***Clemton Park Village, 60 Charlotte Street,
Campsie
Former Sunbeam Factory
Concept Plan MP07_0106 MOD 3***

Director-General's
Environmental Assessment Report
Section 75W of the
Environmental Planning and Assessment Act 1979

January 2013

Figure 2: Proposed building footprints and location of areas of additional building height (shown with the dashed green line)

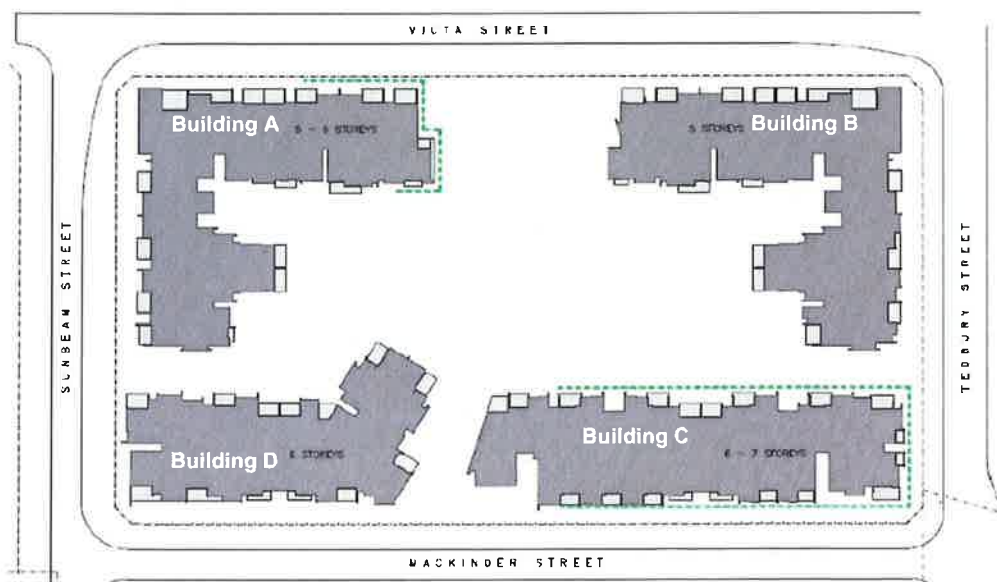
The application seeks approval for building envelopes on Lot 41 (the lot). The proposed envelopes (refer **Fig 2** above) consist of four separate residential envelopes located above a two level basement car park. The residential envelopes extend around the perimeter of the lot and are 5 – 7 storeys in height. The car park envelope extends around the perimeter of the lot in a 'U' shape. The centre of the lot is to be used for open space.

The proponent has prepared detailed designs for the precinct, having regard to its constraints, including ground levels, the terms of approval (in particular the need to provide the central open space area at street level), and access and vehicular constraints. In their design, the basement protrudes above ground level below building C and sits at ground level at the south eastern corner of the building. The proponent seeks to have 6 residential levels in building C and as such the building is 7 storeys in height.

The south-eastern corner of building C is adjacent to low density residential dwellings on Alfred Street. The proposed change in height from 1 - 2 storeys to 7 storeys is abrupt and an inappropriate transition at the edge of the precinct. It is the recommendation of this report that the upper level of building C is setback a minimum of 7m on the south eastern side from the Tedbury Street property boundary to minimise its visual impact on Alfred Street. The setback will also make the height of building C more consistent with the other edge buildings in this part of the precinct which are 5 and 6 storeys and will result in the building form more closely following the fall of the land. The mid section of the building will remain 7 storeys. The mid-section is less visible from Alfred Street and sits more centrally located within the overall precinct, which will provide it with context and is supported.

Building A is located in the northern corner of the precinct. Building A extends along Victa Street, which falls in an easterly direction. The fall of the land creates a space below the ground floor level, which the proponent wishes to use for habitable purposes. The effect of this will be to increase the height of the building at its south-eastern end from 5 to 6 storeys. The change will have a minimal impact on height, with the floor only generally protruding a half level above the street.

The proposed residential envelopes do not comply with the separation requirements of the Residential Design Flat Code. Buildings A and D are separated by 8.5m, buildings D and C by 9m and buildings B and C by 8.5m. To achieve compliance with the Code all would require separation of 12m for the lower 4 storeys and 18m for the upper storeys.

The rules of thumb in the RFDC recommend that 70% of apartments in high density urban areas receive 2 hours sun light in midwinter. The proposed envelopes include a potential apartment layout under which 65% achieve 2 hours through windows and a further 5% are able to receive 2 hours sun light through roof lights. The rules of thumb further recommend that 60% of apartments should be cross ventilated. Under the potential layout 57% of apartments can be cross ventilated through windows, with an additional 3% able to be cross ventilated though a combination of windows and roof ventilators. The merits of the alternate approach to sunlight and ventilation can

Approximately 23% of apartments are single aspect south (SE and SW) facing. The rules of thumb recommend that only 10% of apartments should be single aspect south facing. The high numbers of south facing units are a result of the buildings following the perimeter of the site. There is the potential to consolidate apartments and provide additional cores to achieve greater consistency with the rule of thumb. Detailed consideration of this issue can occur with future development applications.
